SDCI PROJECT #: 3033321-LU, 943 NW Market St.

EDG1 - PRIORITIES & BOARD RECOMMENDATIONS

EDG2 - ADMINISTRATIVE SECOND EARLY DESIGN

AEGIS OF BALLARD
DESIGN RECOMMENDATION PACKET
11.18.2020
#3035145-EG

SECTION THROUGH DRIVEWAY

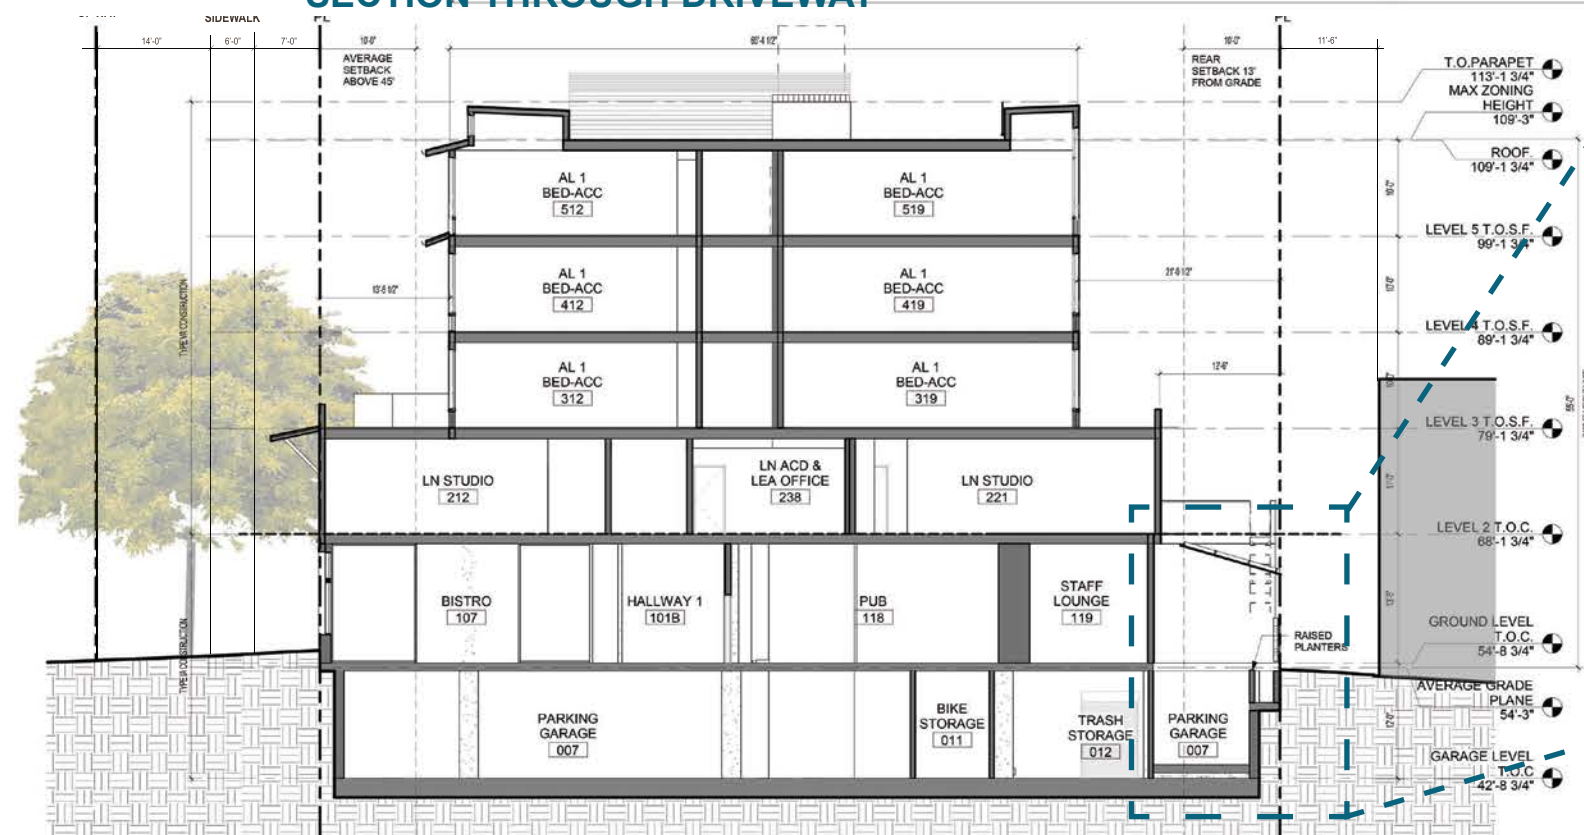
- Staff supports the driveway screening method as proposed on pg. 33 of the EDG 2 packet, provided the detailing is integrated with the architectural concept. (DC2-A Massing, DC1-B-1 Access Location and Design, DC1-C-2 Visual Impacts)
- Staff is also supportive of the trellis over the driveway, but additional details need to be provided at the Recommendation phase on how plantings would be provided for the trellis and how the wall along the property line will be treated. The trellis and wall should be an extension of the design concept and not appear as tacked on. (DC2-A Massing, DC1-B-1 Access Location and Design, DC1-C-2 Visual Impacts)

- Planting strips in the form of raised planters are added to the base of the wall along the property line on the driveway side to grow vines covering the trellises. Please see section and plan shown on MUP sheets A2.1.2 & A6.1.1.
